February 23, 2024

RE: Overland - EIS Comment
Summit Carbon Solutions Pipeline
PUC Docket IP7093/PPL-22-422

Figure 5-6 Noise Sensitive Receptors by Distance from Centerline

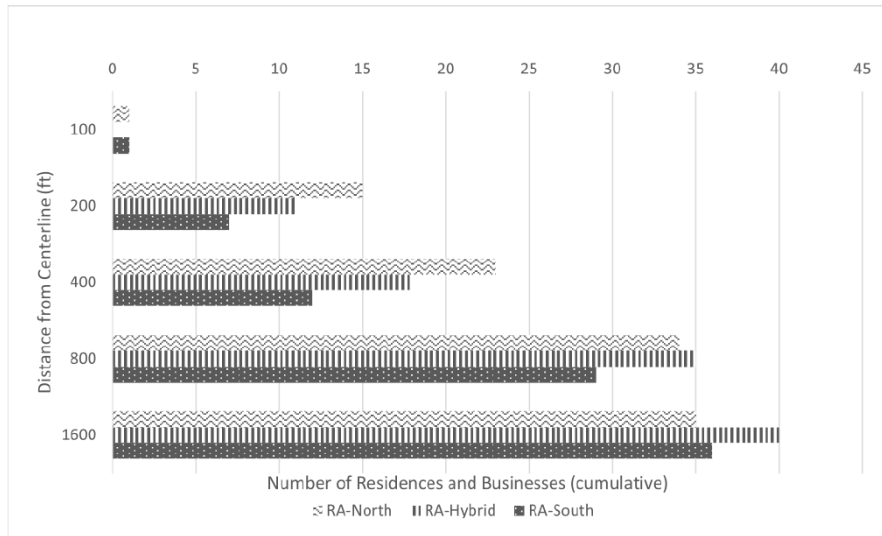
numbers of “sensitive receptors” in the chart label, but the description is “Number of Residences and Businesses,” and which is **NOT** the number of “noise sensitive receptors.”

This is misleading. The chart should be changed to show the “Number of Noise Sensitive Receptors” by taking the average number of people in a household and multiplying by the numbers shown in the X axis. The edge of the right-of-way numbers should also be displayed on Y axis, labeled as “250 – Edge of RoW” so that it can be easily determined the impacts on those outside of Right of Way.” From this chart, assuming there are additional impacts for those within 250 foot of centerline on each side of the RoW, it appears that there are more than 15 residences and businesses (and how many residentTS? Workers?). This is a serious flaw in the noise impact analysis. The EIS is inadequate as it does not address numbers of individual “receptors” in residences and businesses, and thus grossly understates impacts.

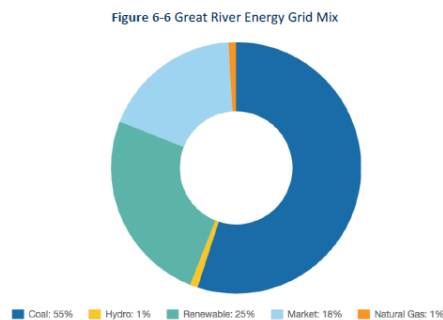
The EIS is inadequate as it does not address that with winter construction noise travels further due to hardpacked snow and frozen ground, a ground factor of 0.0, and that noise will not lessen as fast as it would with summertime ground cover of grasses and trees.
